Submission of Further Information

**Temporary Animal Boarding Establishment with Ancillary Facilities
for a Period of 5 Years and Associated Filling of Land in “Agriculture” Zone,
Lot Nos. 1493 (Part) and 1500 (Part) in D. D. 107 and Adjoining Government Land,
Kam Tin, Yuen Long, New Territories
(S.16 Planning Application No. A/YL-KTN/987)**

Further Information for Planning Application No. A/YL-KTN/987**Response-to-Comment****Comments from the Drainage Services Department**

Connection details of proposed outfall between CP6, S1 and existing culvert

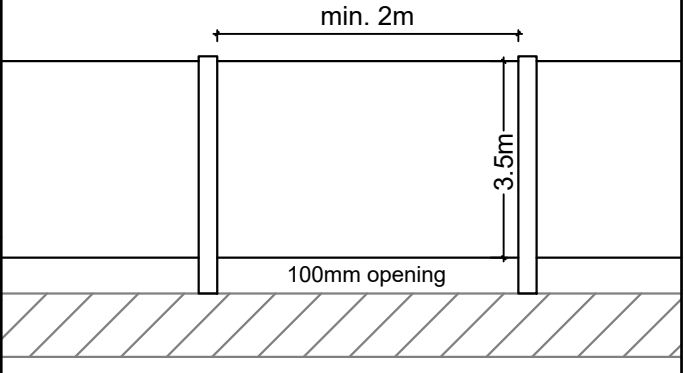
Comments	Responses
1.	Please indicate clearly the full alignment of the discharge path from the application site all the way down to the ultimate discharge point (e.g. a well-established stream course/public drainage system).	The full alignment of the discharge path from the application site all the way down to the ultimate discharge point is added to Plan 5.1a.

2.	The applicant should check and ensure the hydraulic capacity of the existing drainage facilities would not be adversely affected by the captioned development. Please provide site photos to show existing condition of the existing drainage facilities which receives the discharge from the application site.	The existing drainage system on site is covered u-channel. Catch-pits will be provided along the covered u-channel to collect the run-off. Drainage Proposal (Plan 5.1a) is updated.

Details of hoarding with 100mm opening

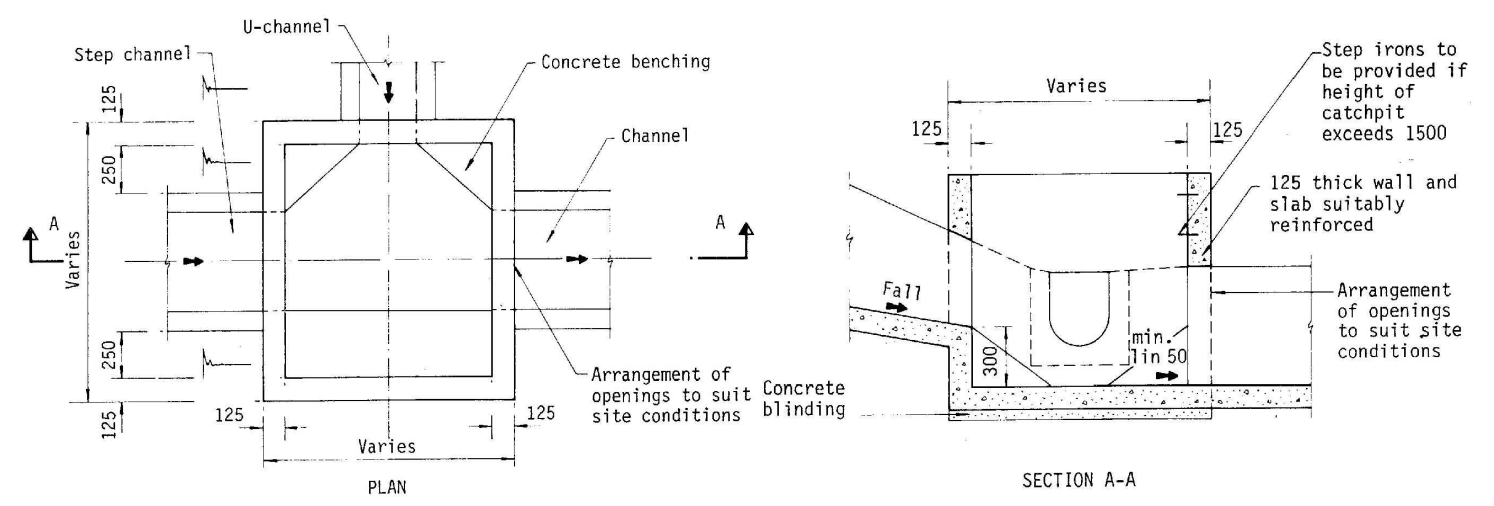
3.	Where walls or hoarding are erected are laid along the site boundary, adequate opening should be provided to intercept the existing overland flow passing through the site. The applicant is reminded to implement the 100mm opening on site.	Noted.

Plan 5.2a (P 23044)

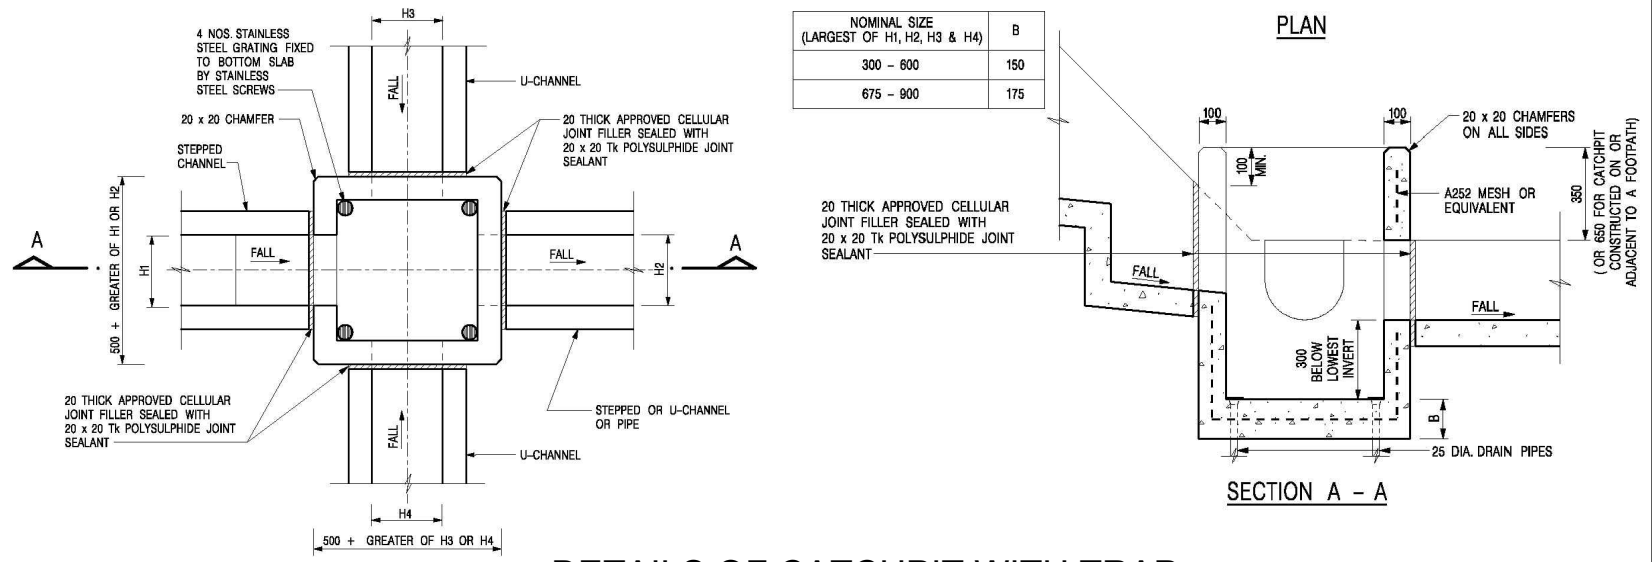
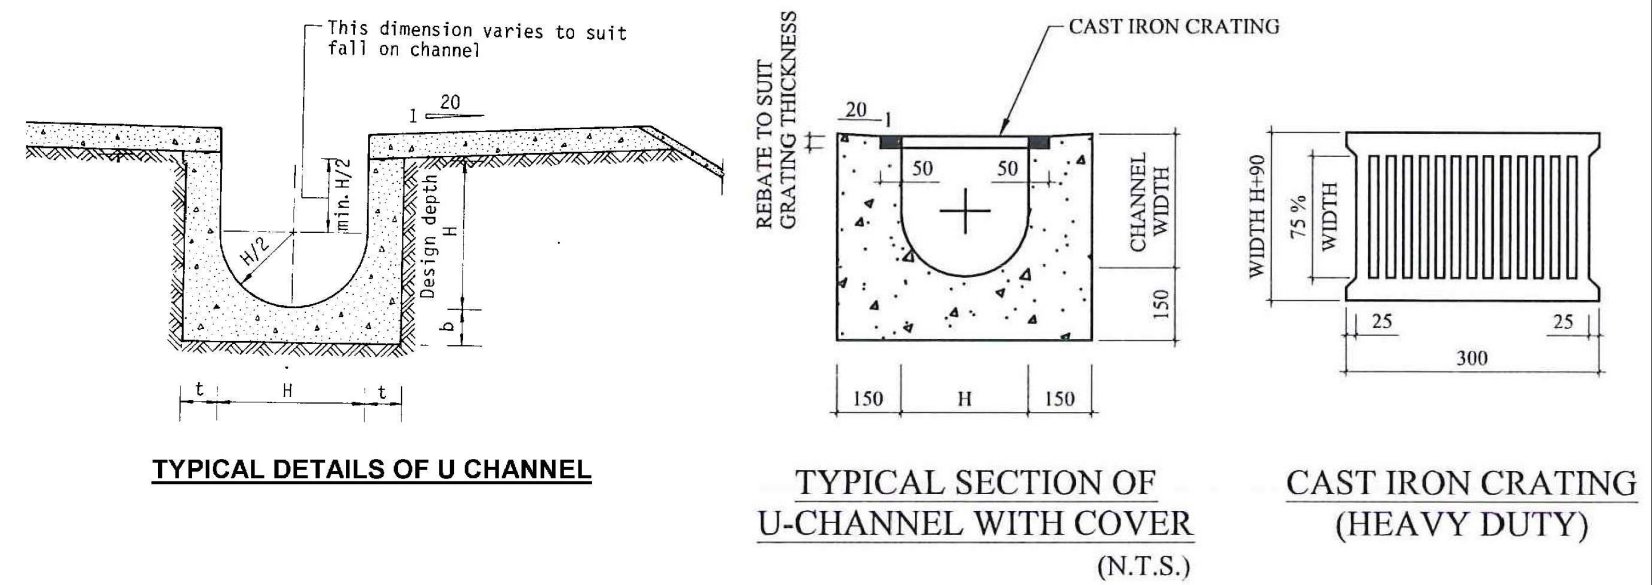
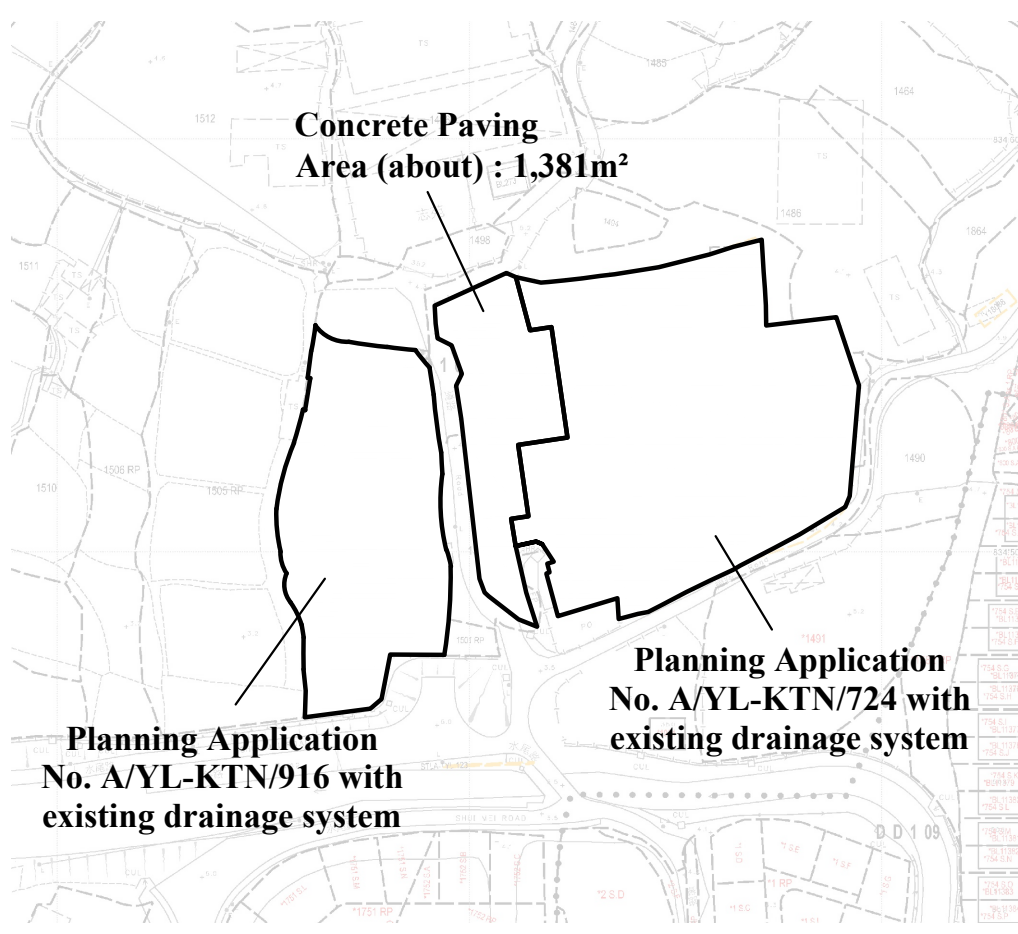
4.	Cross sections should include the existing and proposed ground levels of the captioned site with respect to the adjacent areas. Please update the section with adjacent areas level and review if external catchment is required for assessment.	Planning Application No. A/YL-KTN/724 is at the eastern side of the site. Planning Application No. A/YL-KTN/916 is at the western side of the site. These sites have its own existing drainage system. The section with adjacent areas level is updated. No external catchment is required for assessment. Please refer to updated Plan 5.1a and Plan 5.2a for details.
